**PLANNING DEPARTMENT ADMINISTRATIVE PUBLIC HEARING  
SUMMIT COUNTY, UTAH  
June 12, 2025**

- 1.A. **2979 Arabian Drive – Administrative Permit** – The Applicant Proposes to Construct a 674-square-foot Accessory Apartment with One Bedroom in the Single-Family Zoning District. PL-25-06542.  
(A) Public Hearing; (B) Action

**Subject:** 2979 Arabian Drive  
**Application:** PL-25-06542  
**Author:** Elissa Martin  
**Date:** June 12, 2025  
**Type of Item:** Accessory Apartment – Administrative Permit

### NOTICE OF PLANNING DIRECTOR ACTION

Figure 4: Site Plan showing the new footprint of the SFD with the upper-level Accessory Apartment overlaid in blue

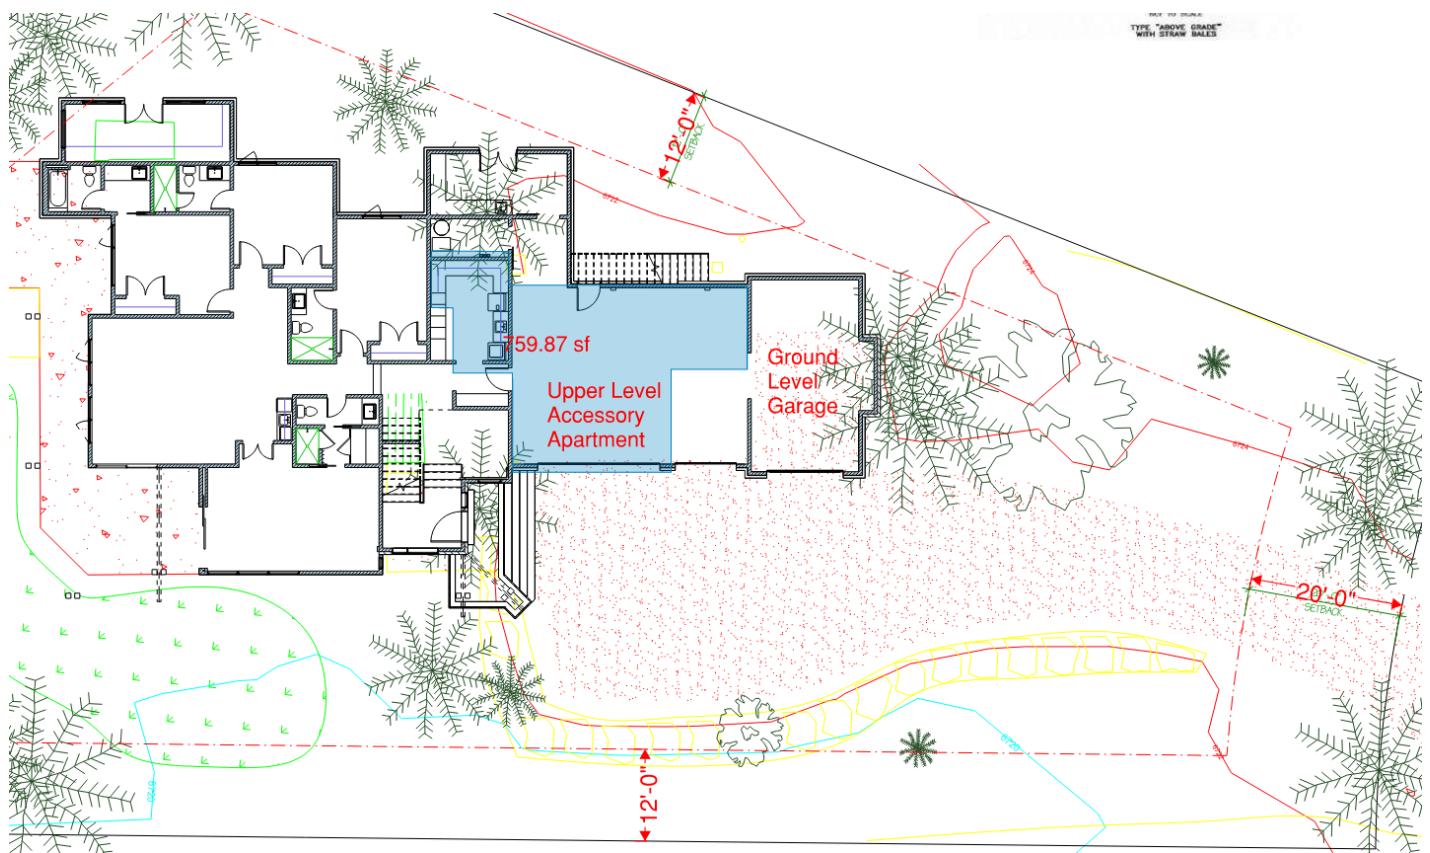
| Rear Setback – 15 feet                                                                                                                                                                                                                                                        | COMPLIES: While the proposed internal Accessory Apartment complies with the Rear Setback (see figure 4 below), the new footprint of the SFD encroaches into the Rear Setback approximately three feet and will need to be modified in the Building Permit for Planning Department review. |

| Requirement             | Analysis of Proposal                                                                                                                                                                                                                                                                      |
|-------------------------|-------------------------------------------------------------------------------------------------------------------------------------------------------------------------------------------------------------------------------------------------------------------------------------------|
| Rear Setback – 15 feet  | COMPLIES: While the proposed internal Accessory Apartment complies with the Rear Setback (see figure 4 below), the new footprint of the SFD encroaches into the Rear Setback approximately three feet and will need to be modified in the Building Permit for Planning Department review. |
